JULY 7, 2016

**NEIGHBORHOOD STREETS INITIATIVE OVERLAY 2016**  
**CONTRACT NO. C02070**  
**ADDENDUM NO. 1**

**Typical Street Sections**  
Neighborhood Streets Initiative Overlay 2016  
Contract Number CO2070

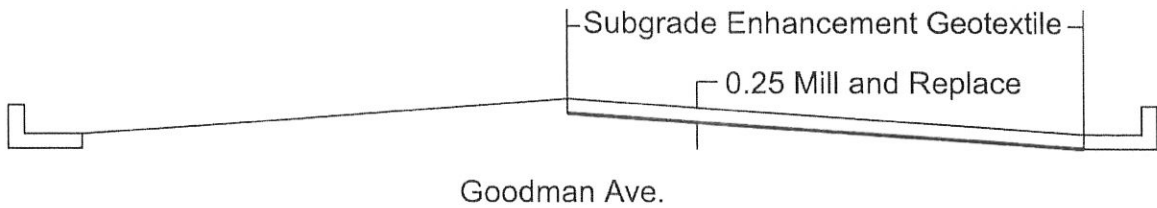
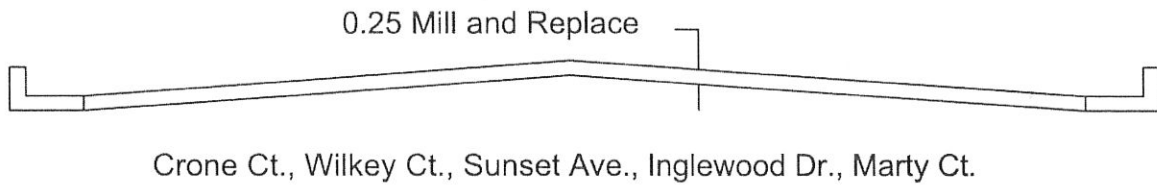
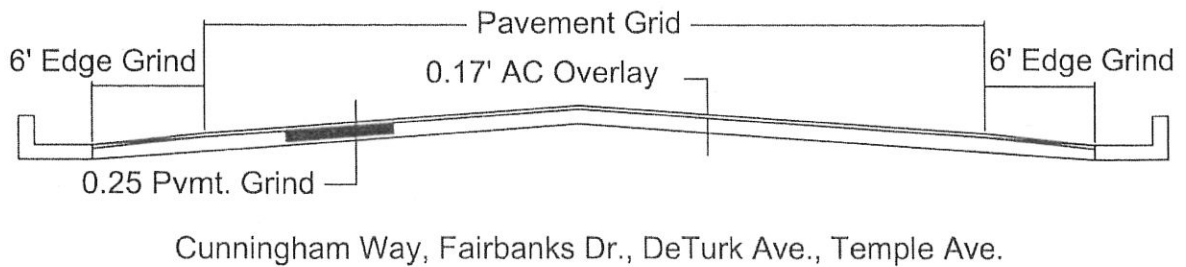
15. For clarification on typical pavement treatment method at each location, page 58-1 shall be inserted after page 58R.
